**REHABILITATION OF THE SUROOR
ELEMENTARY SCHOOL
UNDER THE ECONOMIC SUPPORT FUND
HUSSEINIYA, IRAQ**

SUSTAINMENT ASSESSMENT

**SIGIR PA-08-135
APRIL 7, 2009**

SUBJECT: Report on Sustainment Assessment of the Rehabilitation of the Suroor
Elementary School, Husseinia, Iraq (SIGIR Report Number PA-08-135)

Figure 2. Architectural layout of the school after renovation (Courtesy of GRC)

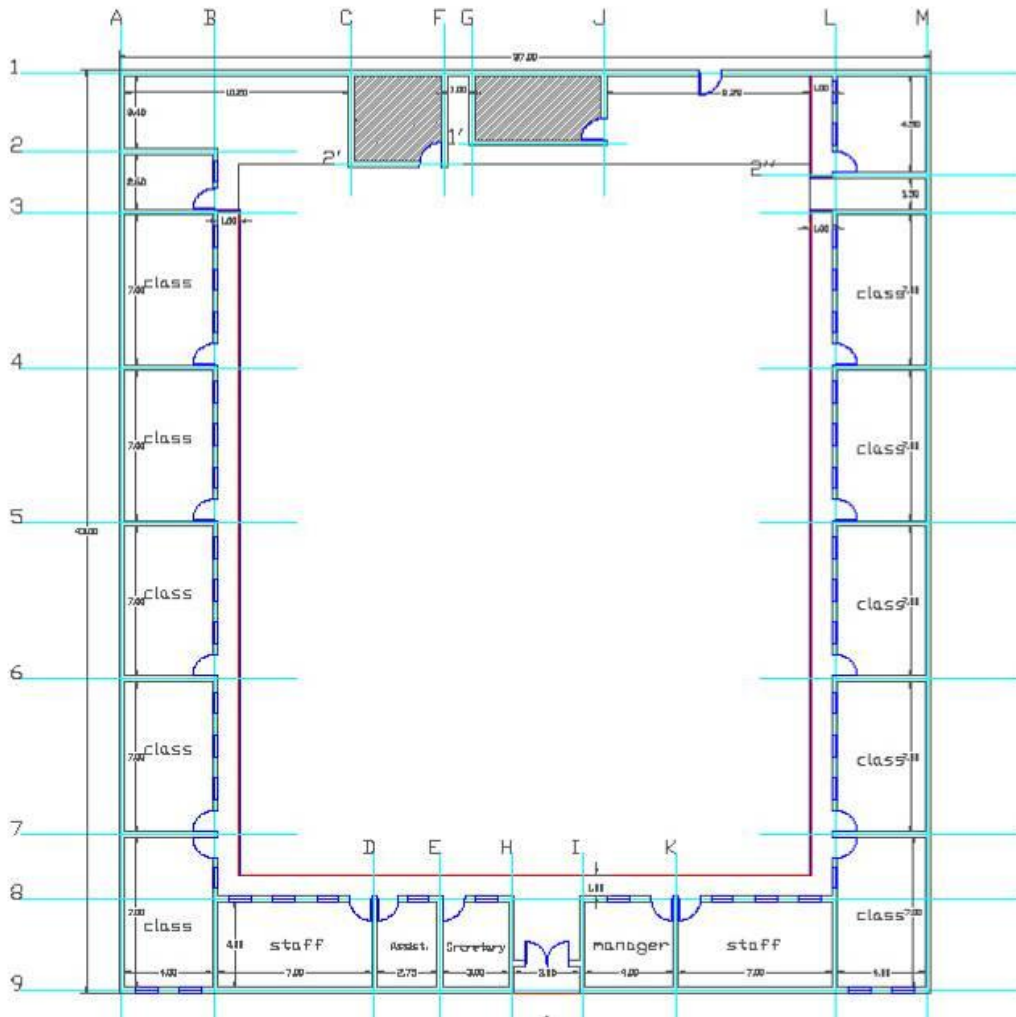
The architectural plans show the layout of 10 classrooms, 2 staff rooms, and administration areas (Figure 2). While the contractor’s submittals included good details of the electrical distribution system, our review concluded that the design submittals did not appear adequate for the renovation project because of the omission of details such as elevations, plumbing, and storm drainage.

GRD disagreed and stated it was “appropriate for the contractor not to include storm drainage details in their submittal” since the SOW did not specifically address storm drainage or civil site work. However, this project included the replacement of colored tiles in the courtyard; therefore, civil site work designs were necessary and drainage for the courtyard needed to be addressed by the contractor in the design submittals.

Command Comment. The lack of plumbing details in the design submittals is appropriate since the draft report mentions in the first paragraph on page 3, "The school's administration told GRC that work previously identified by the PRT, such as the school's plumbing, was being done under a separate Government of Iraq (GOI) contract." The list of items addressed in the SOW on page 3 does not mention any requirement for storm drainage or civil site work, so it is also appropriate for the contractor not to include storm drainage details in their submittal.
